**City of Biddeford
Planning Board**

December 3, 2025 at 5:00 PM
City Hall Council Chambers & Zoom

Planning Board – Staff Report

RE: Case # 2025.50 (Prior Case # 2021.04 - Final Subdivision and Site Plan approval) request for Adams Point Housing – Southern Maine Affordable Housing / 69 Adam's Street (Tax Map 38, Lot 296) for 39 residential units – Proposed Landscaping Amendment.

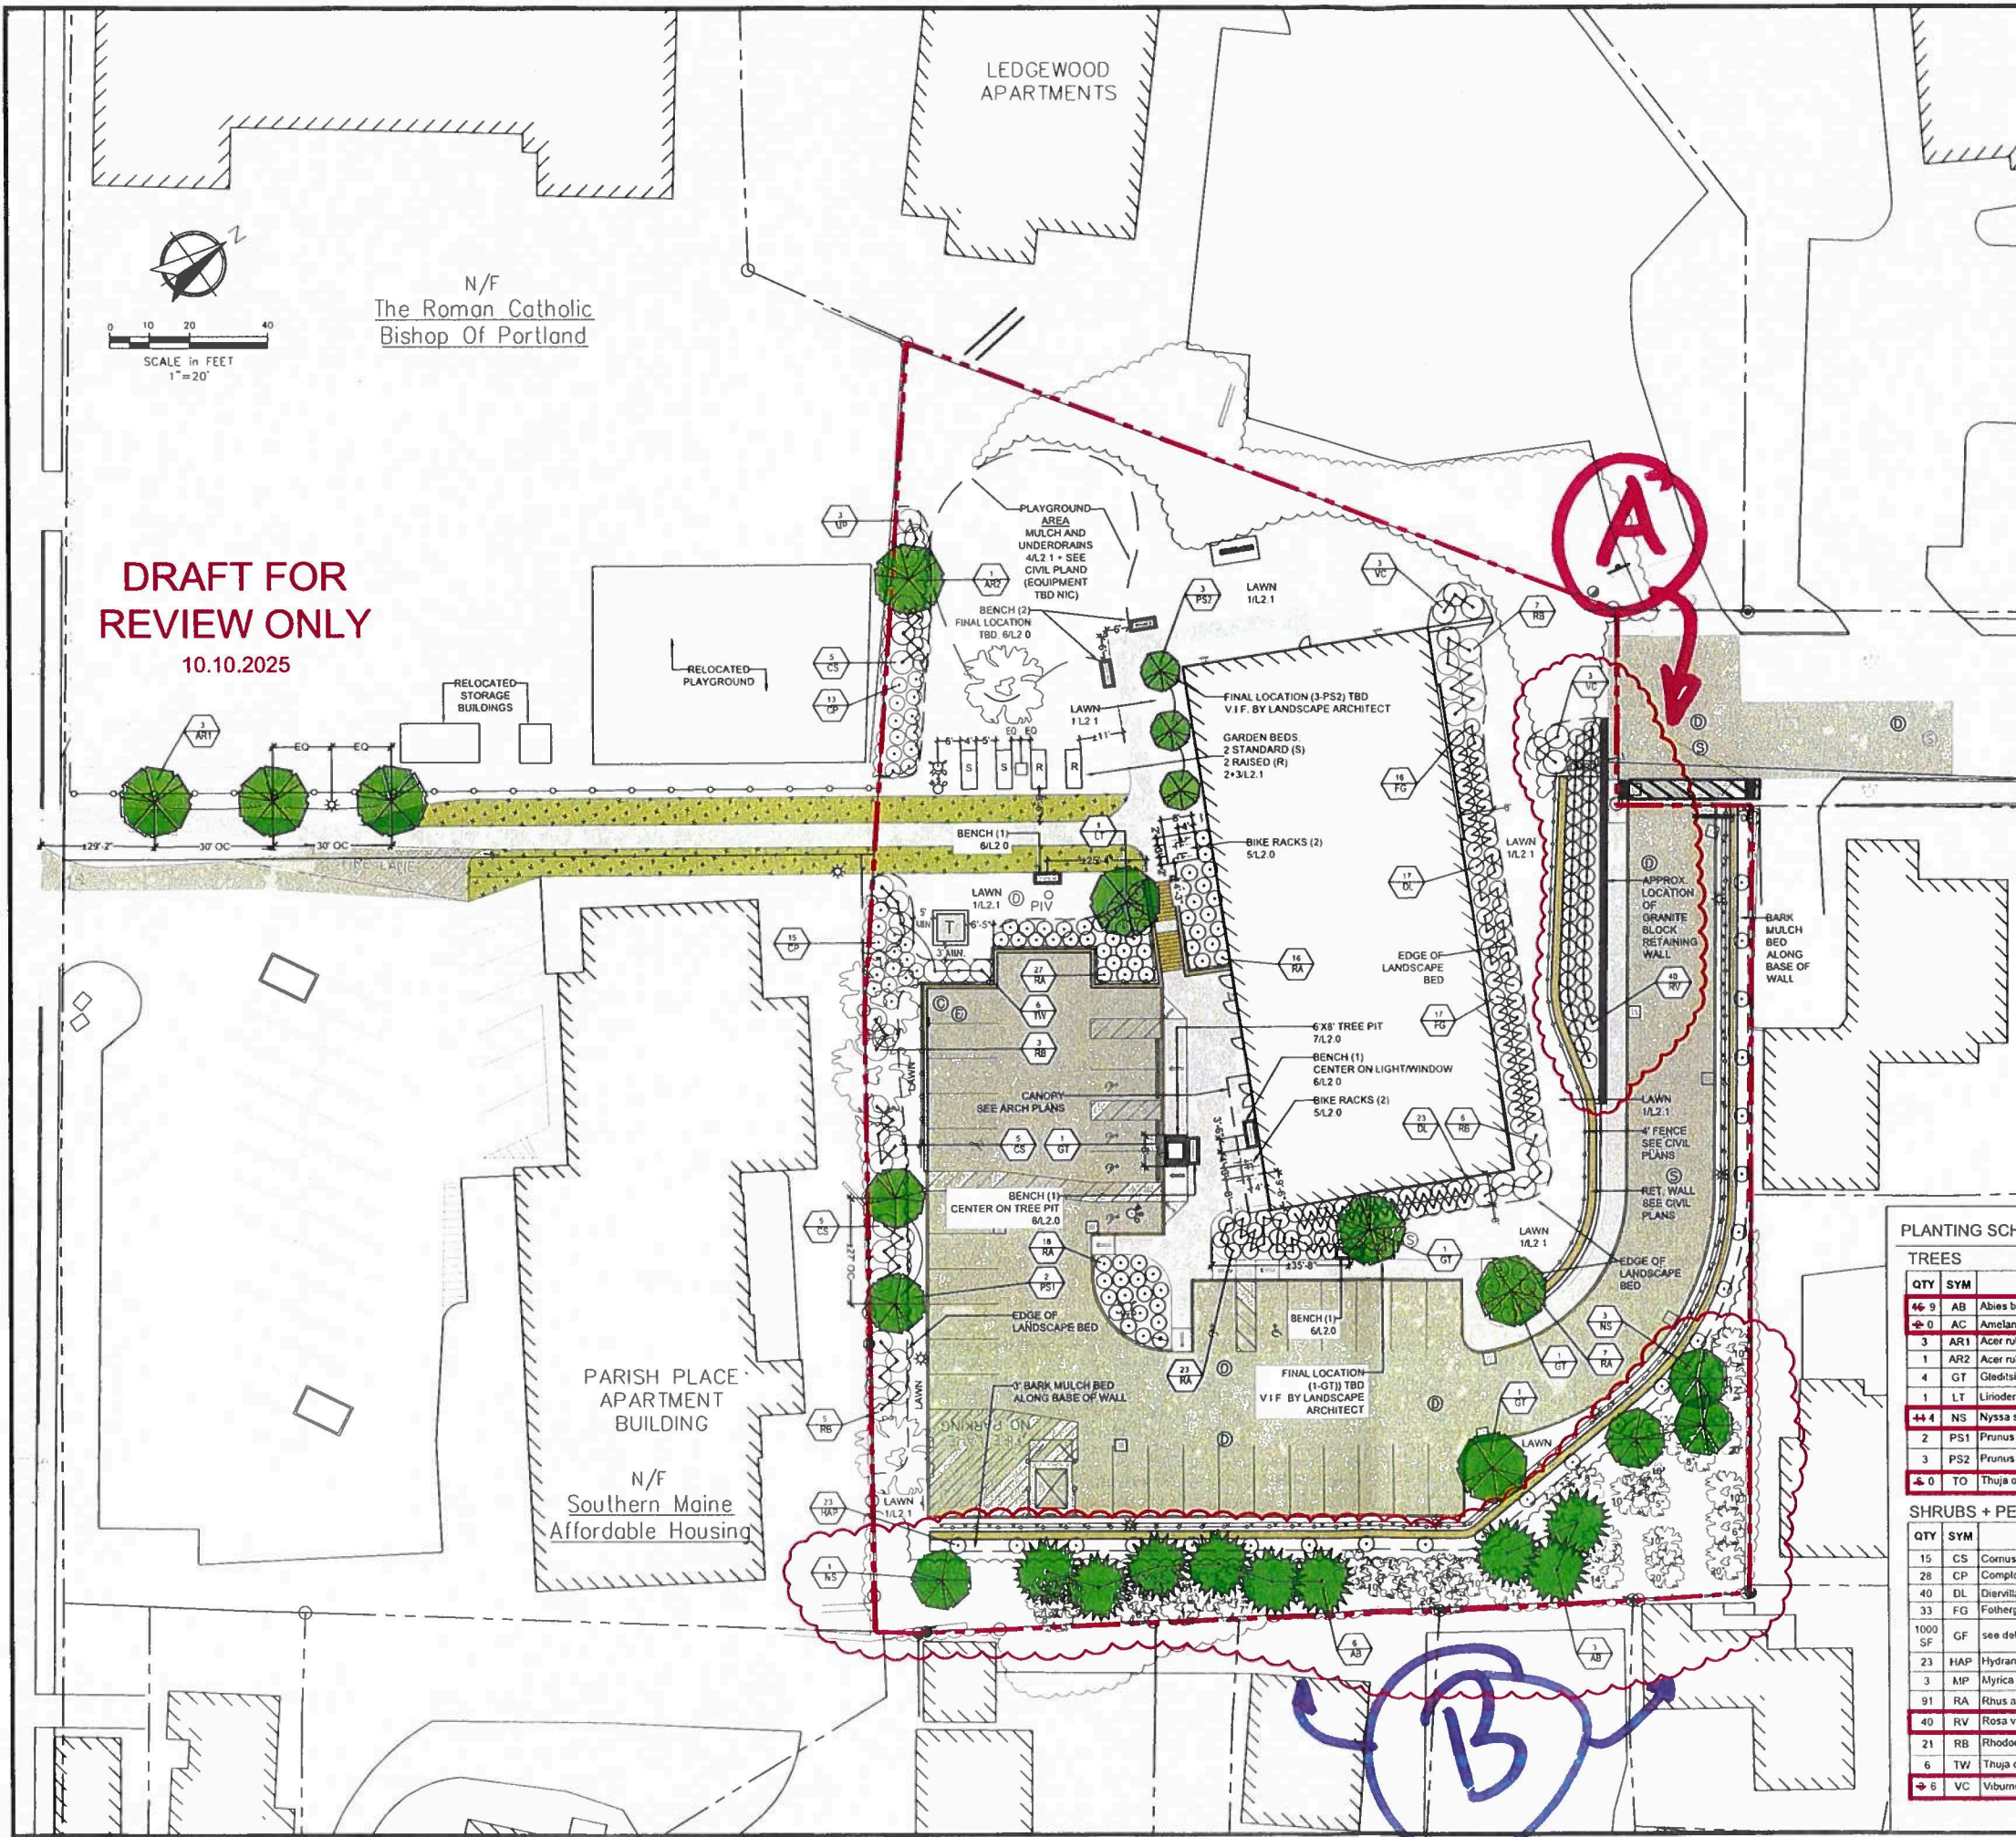
Our request for changes to the landscape plan stems from the fact that we were able to save a large percentage of the existing trees lining the northeast corner of the site. This was a welcome surprise and will guarantee the neighbors continued shading and canopy coverage for the area.

The attached plan notes the changes being proposed but in summary these are the changes requested and reason behind them.

- a. The western portion of the site near entrance to Adams street (marked "A" on the plan) is where we plan to add more plantings to provide a more appealing entrance and also to assist with erosion control below the new block wall and above the granite bolder shorter wall. These are all new additional plantings not originally shown on the plan.

- b. The revised schedule of plantings is noted on the attached landscape plan. It includes the additions to area "A" and also the reductions proposed for area "B"

- c. Noted in the original application was the potential for the loss of most of the existing mature tree growth in the lower wall area (shown as area "B") At that time, the plantings proposed made sense since they would be replacing the loss of vegetation expected. However, during construction of the new driveway and retaining wall, much of the existing tree canopy was not impacted and is expected to survive without damage. Therefore, the proposal to reduce new plantings makes sense for a number of reasons, all of which have been endorsed by the landscape designer, Matt Phillips, who provided this new landscape plan for your consideration.

- d. The proposed plan takes into consideration that excavating for new plantings could not only risk the health of existing trees but could make it impossible to even dig into the ground where numerous roots are just below the surface.
- e. Matt Phillips and a representative from Oak Point Associates, conducted a site walk and the resulting proposal is a commonsense plan for including some new plantings in available areas.
- f. It should be noted that the 23 climbing Hydrangea plants are still being installed at the base of the wall to soften that tall retention wall.
